# Conditions

# Results

# Summary

Target cell  
(Cell5 in Module2)

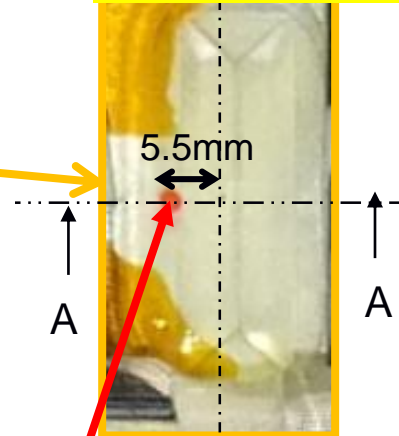
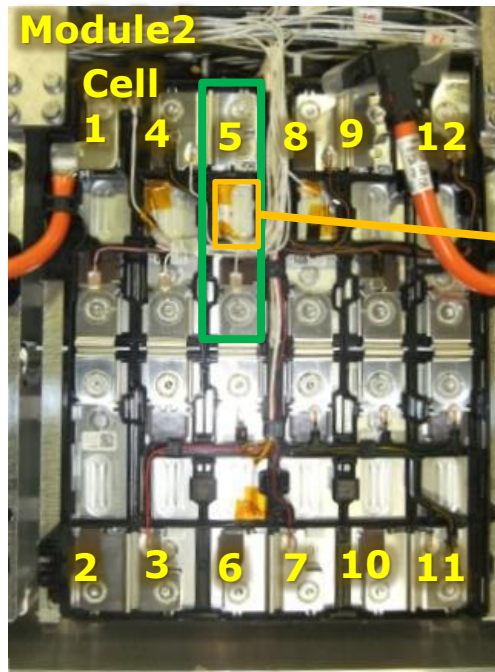
Need to test multiple locations to confirm worst-case scenario. TP depends on heat transfer, and a thermal runaway in this location is surrounded by more thermal mass heat sinks, which may result in heating adjacent cells and a lower temperature overall. An edge cell, surrounded by air may transfer more of its energy to the fewer adjacent cells. It may also swell more before venting (less pack pressure), which may affect venting time and TP.

Section A-A

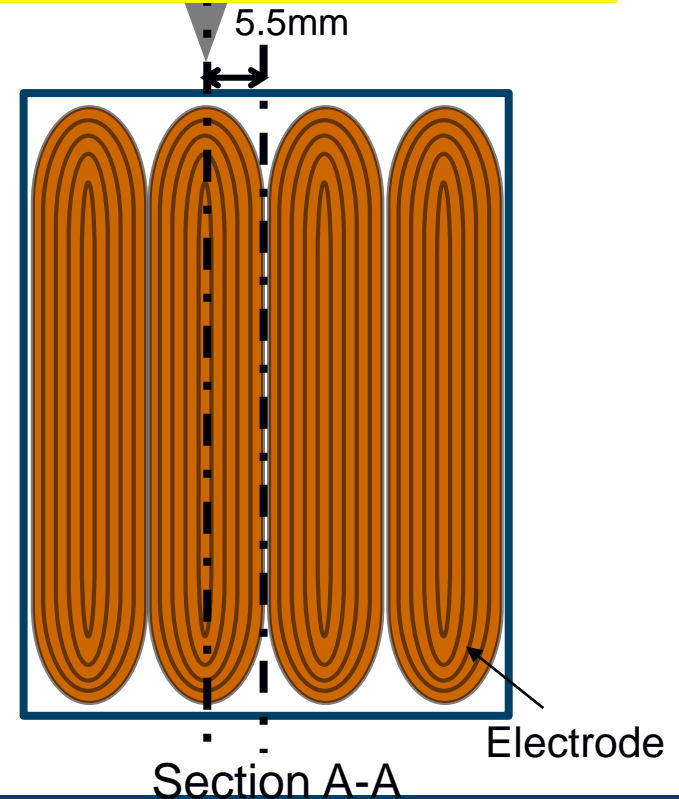
This will require knowledge of inner electrode construction, Where does this information come from?

How does location accuracy of test affect outcome?

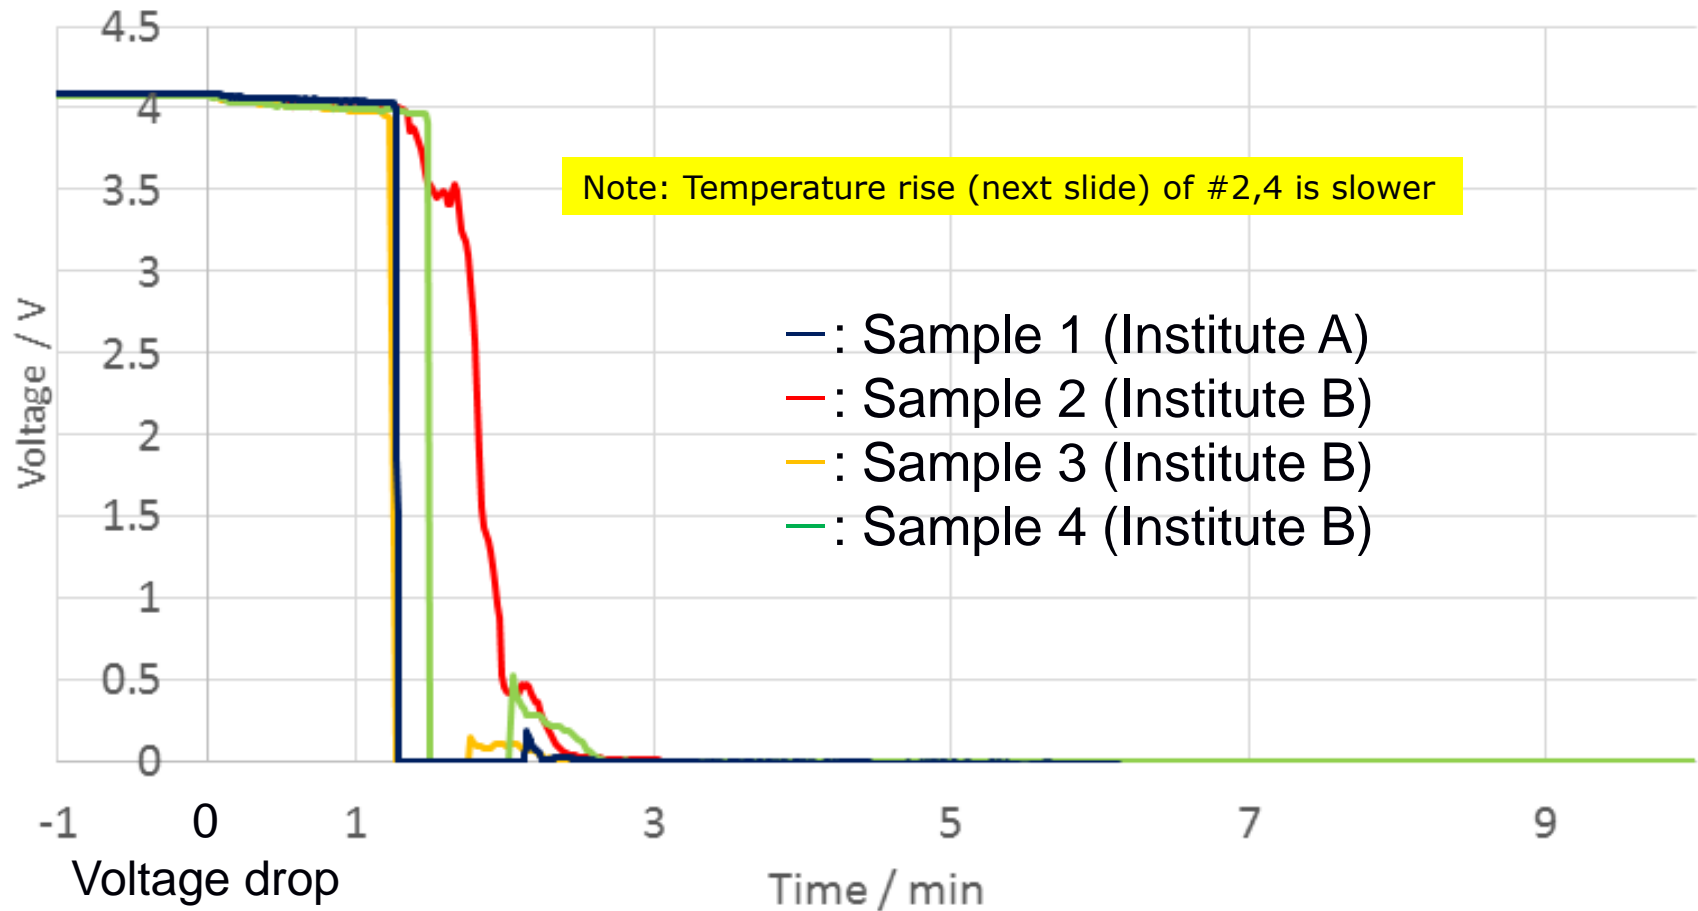
What does arrow mean?

# Difference of short term temperature

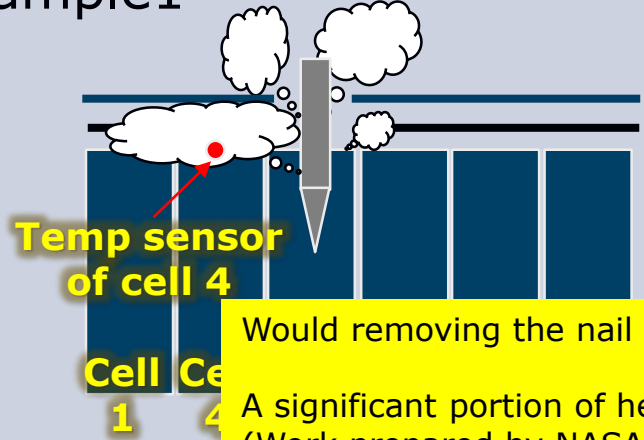
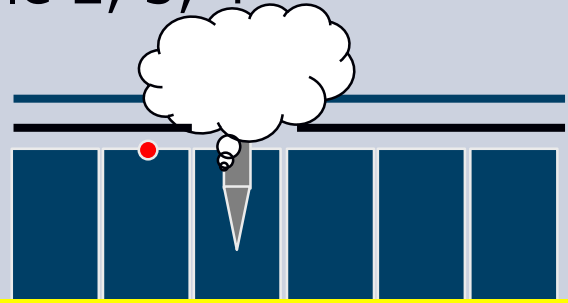
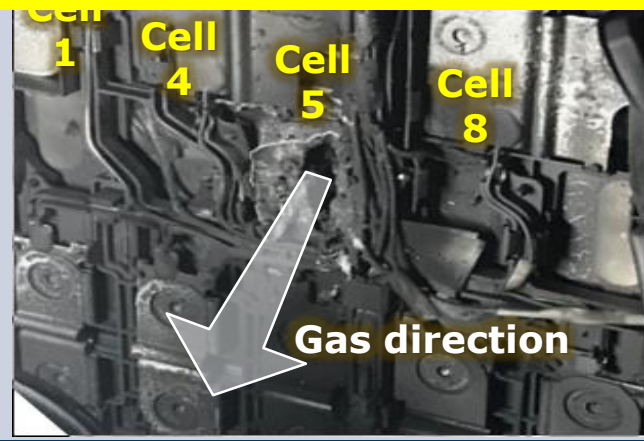
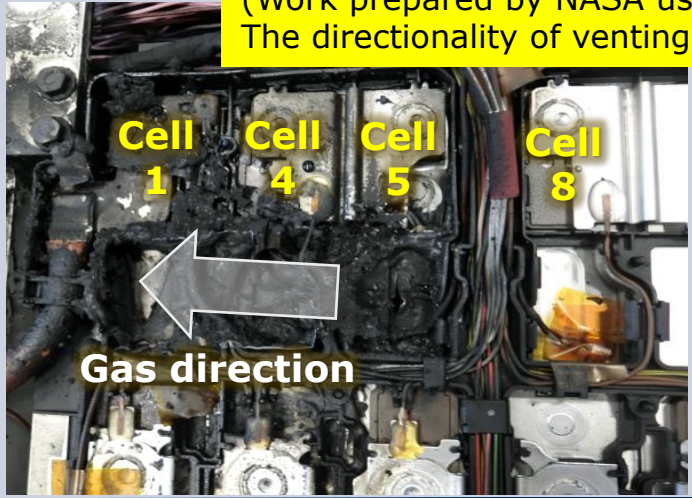
Would removing the nail after insertion help this?  
A significant portion of heat released is through the mass transfer of venting gases (Work prepared by NASA using a battery calorimeter estimates up to 40% of the total energy). The directionality of venting gases is an important consideration, but can be stochastic.
